Addendum No. 02

Subject: Julia R. Masterman High School – Elevator
Replacement SDP Contract No. B-069C 2018/2019

This Addendum dated February 24, 2021 shall modify and become part of the Contract Documents for the work of this project. Any items not mentioned herein, or affected by, shall be performed strictly in accordance with the original documents.

NO.	DATE	REVISIONS	INT.	TITLE:		
				ELEVATOR REPLACEMENT		
				JOB: B-069 C		
				DRAWN BY: FJR		
				CHECKED BY: BAM		
				DATE: 02.24.2021		
				REF. DWG. E-102		
				DRAWING NO. SK-1		
SCHOOL DISTRICT OF PHILADELPHIA MASTERMAN HIGH SCHOOL  VALLEY FORGE, PENNSYLVANIA

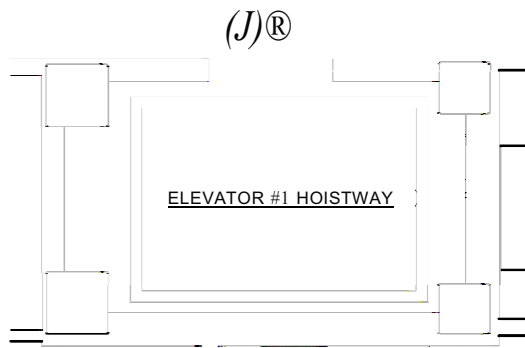
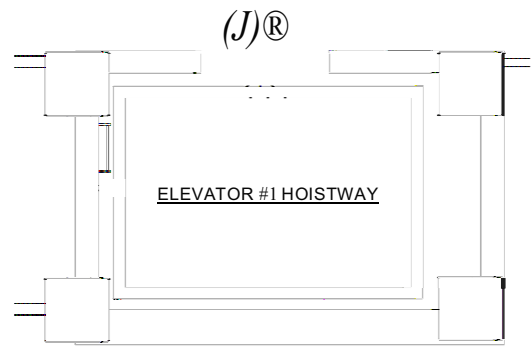
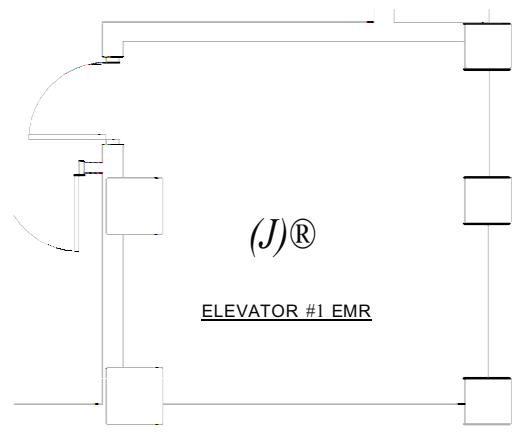
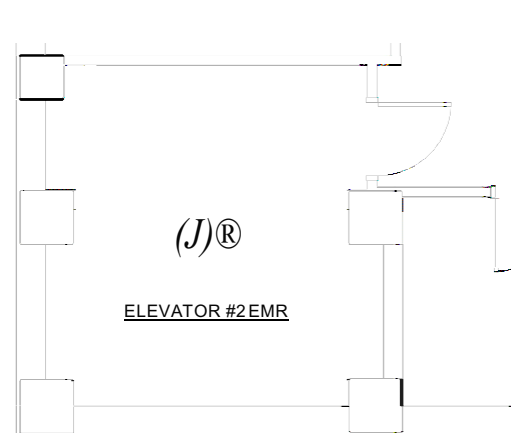
Detail 3 on Drawing E-103 calls to connect elevator recall modules to an existing fire alarm addressable loop. The fire alarm is not an addressable system, it is an old Couch, 120v system. The addressable modules and elevator recall cannot be connected to this system. Drawing notes tell us to verify existing lobby smoke detectors, elevator & machine room heat detectors, they do not exist. How do we proceed to get an elevator code compliant fire alarm system?

1. PROVIDE (1) ELEVATOR RECALL CONTROL AND SUPERVISORY PANEL (ERCSP) IN BUILDING ENGINEER'S OFFICE. INTEGRATE ERCSP WITH EXISTING FIRE ALARM CONTROL PANEL FOR SUPERVISORY, TROUBLE, AND ALARM SIGNALS. PROVIDE A TOTAL OF FIFTEEN (15) CEILING/WALL-MOUNTED (FIELD VERIFY) SMOKE DETECTORS-ONE AT EACH ELEVATOR LANDING, ONE IN EACH WITH BUILDING ENGINEER). PROVIDE ALL CONDUIT AND WIRE REQUIRED FOR THESE SYSTEMS. ELEVATOR

MACHINE ROOM, AND ONE AT THE ERCSP IN THE BATTERY & SWITCHBOARD ROOM (COORDINATE EXACT LOCATION

- **Response:** Provide an Elevator Recall Control and Supervisory Panel (ERCSP) and Integrate that panel with the existing Fire Alarm system. Provide fifteen (15) smoke detectors to support the new elevator system. Integrate these smoke detectors with the new ERCSP. Refer to attached sketches SK-1, SK-2, SK-2.1, and SK-2.2.

E-102: Add Keyed Note #11: “Provide (1) Elevator Recall Control and Supervisory Panel (ERCSP) in Battery & Switchboard Room. Integrate ERSCP with existing fire alarm control panel for Supervisory, Trouble, and Alarm Signals. Provide a total of fifteen (15) ceiling-mounted smoke detectors – one at each elevator landing, one in the elevator machine room, and one at the ERCSP. Provide all conduit and wire required for these systems.”

E-102: Add smoke detector to elevator machine room on plans #5 & #7. Add keynote indicator #11 at this smoke detectors.

@. 7 TRICAL ONE LINE DIAGRAM - NEW WORK

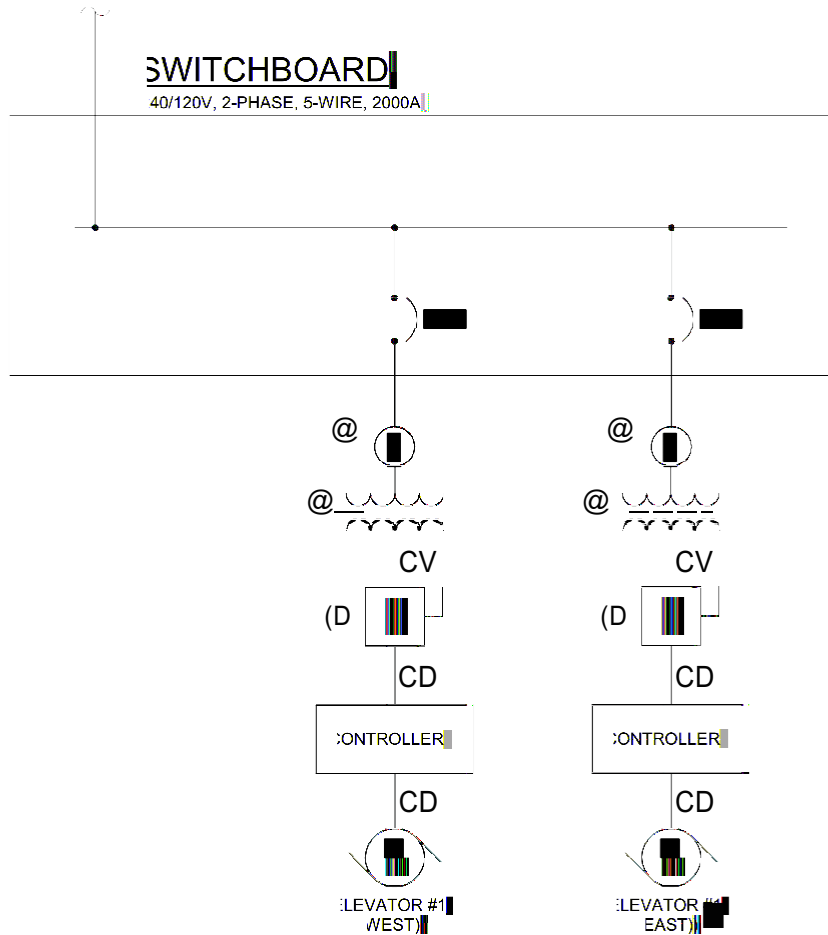
Detail 2 on drawing shows a 2 phase, five wire, 120/240v Main Distribution Panel with three pole breakers feeding elevators?? The existing elevator service is two phase (picture attached). How do we connect the two-phase service to the new three phase elevators?

- **Response:** Existing breakers are 4 pole. Provide (2) new Scott-T transformers. Connect existing elevator feeders to new Scott-T transformers; modify/extend existing feeder as required. Refer to attached sketch SK-3.

1. 100A, 240V, 3 POLE SHUNT TRIP FUSED DISCONNECT SWITCH PER SPECIFICATION SECTION 26 28 16.17.
2. CONNECT EXISTING ELEVATOR FEEDER TO NEW "SCOTT-T" TRANSFORMER; MODIFY/EXTEND EXISTING FEEDER AS REQUIRED, NEW WIRING TYPE/SIZE TO MATCH EXISTING.
3. PROVIDE NEW "SCOTT-T" TRANSFORMER: 37.5 KVA, 240V, 2 PH, 4W PRIMARY X 240V, 3PH, 3W SECONDARY.
